PUBLIC INTEREST REVIEW FOR GROUND WATER APPLICATIONS

SUBJECT: Application **G-17548** Supersedes review of _____
Date of Review(s)

Applicant's Name: **Schofield Family Limited Partnership** County: **Lake**

Proposed Well 1 to Crooked Creek

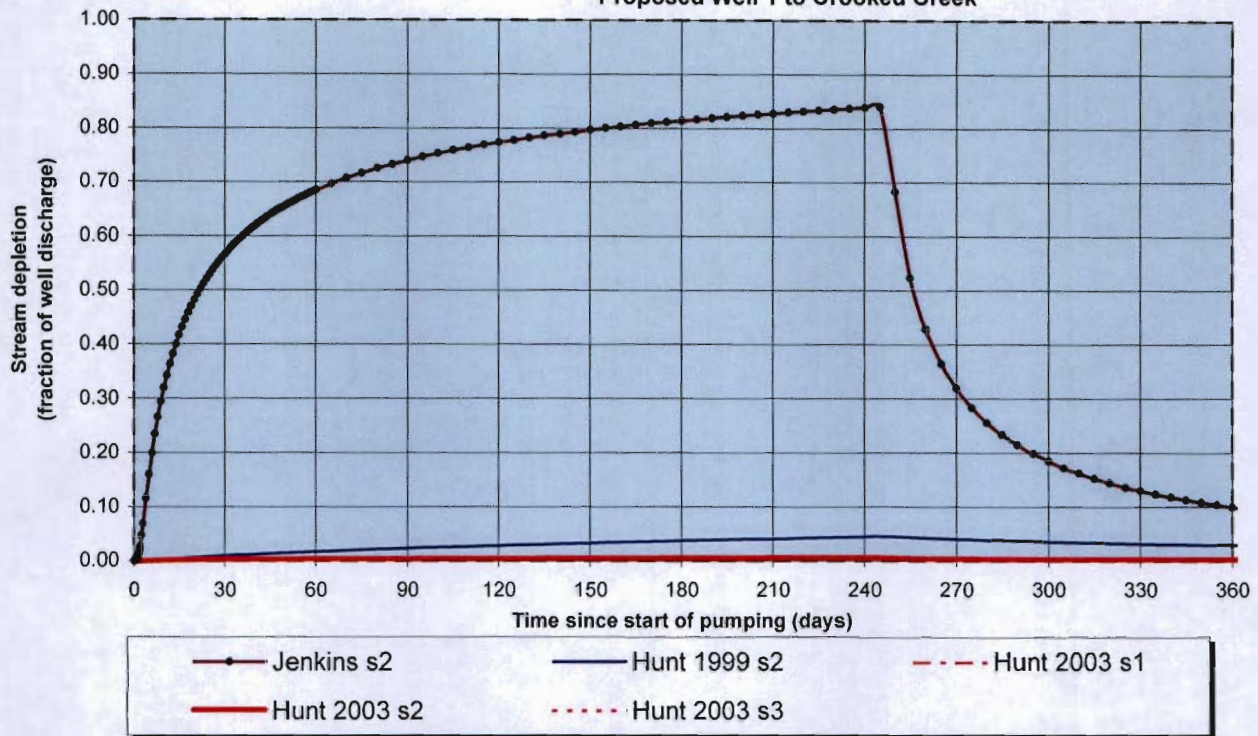
SW# 1 is Crooked Creek. Both of the proposed wells are more than 1.0 mile from Crooked Creek.

Hunt (2003) was used to calculate the interference given the recommended condition that the wells obtain groundwater from the predominantly basalt unit below the predominantly basin fill sediment unit. The calculations used a horizontal hydraulic conductivity of 30 feet/day (transmissivity = 15,000 ft²/day which is consistent with Morgan (1988) and McFarland and Ryals (1991)), a vertical conductivity of 0.3 feet/day, 0.01 for the storage coefficient, and a basin-fill sediment thickness of 350 feet at the stream (based on LAKE 52274). The stream width used for the calculation (100 feet) is likely greater than the actual stream width. A smaller stream width would result in a smaller calculated interference.

When obtaining groundwater from the predominant basalt unit, the calculated interference with the creek for each month remains less than 1.00 percent of the natural stream flow (80 percent exceedance). It should be noted that pumping groundwater from the predominantly basin-fill unit would likely result in interference with the creek that exceeds the 1.00 percent of the natural stream flow (80 percent exceedance) during some months. That is a major reason why groundwater needs to be obtained from the predominantly basalt unit only.

Proposed Well 1 to Chewaucan River

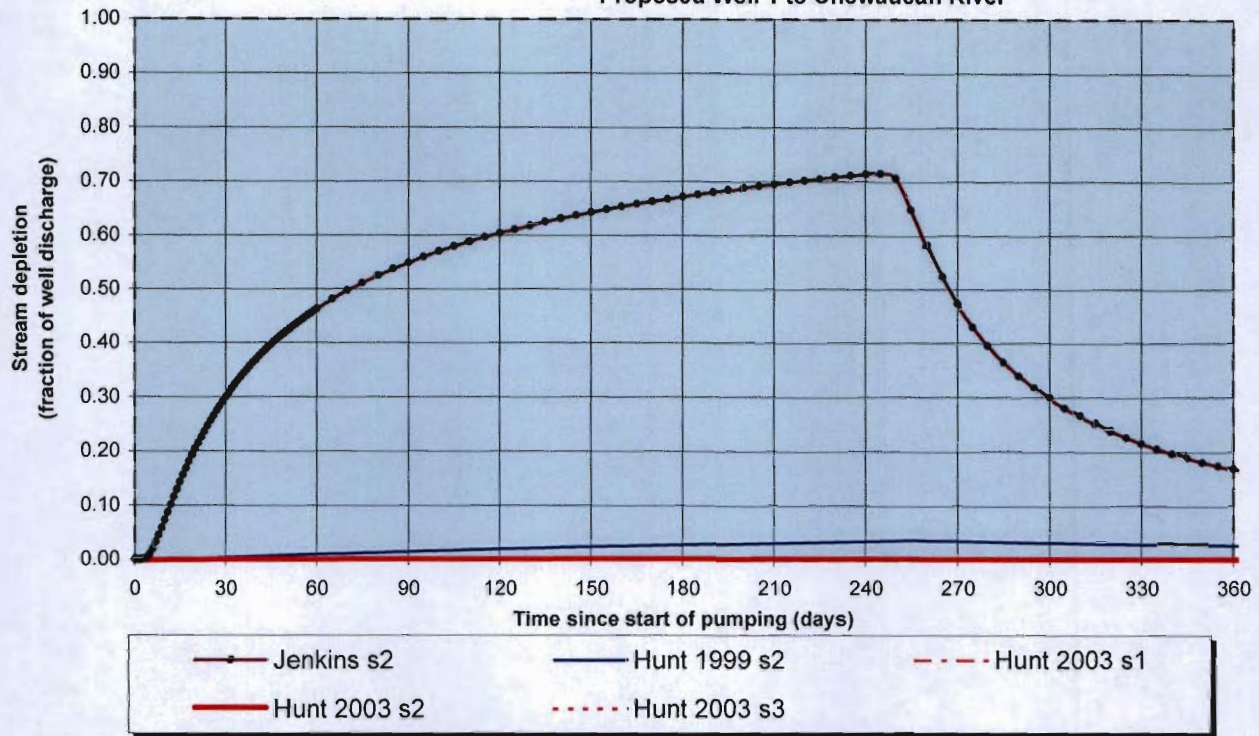
SW# 2 is the Chewaucan River. Both of the proposed wells are more than 1.0 mile from the Chewaucan River.

Hunt (2003) was used to calculate the interference given the recommended condition that the wells obtain groundwater from the predominantly basalt unit below the predominantly basin fill sediment unit. The calculations used a horizontal hydraulic conductivity of 30 feet/day (transmissivity = 15,000 ft²/day which is consistent with Morgan (1988) and McFarland and Ryals (1991)), a vertical conductivity of 0.3 feet/day, 0.01 for the storage coefficient, and a basin-fill sediment thickness of 350 feet at the stream (based on LAKE 52274). The stream width used for the calculation (100 feet) is approximate to the actual stream width. A smaller stream width would result in a smaller calculated interference.

When obtaining groundwater from the predominant basalt unit, the calculated interference with the river for each month remains less than 1.00 percent of the natural stream flow (80 percent exceedance). It should be noted that pumping groundwater from the predominantly basin-fill unit would likely result in interference with the river that exceeds the 1.00 percent of the natural stream flow (80 percent exceedance) during some months. That is a major reason why groundwater needs to be obtained from the predominantly basalt unit only.
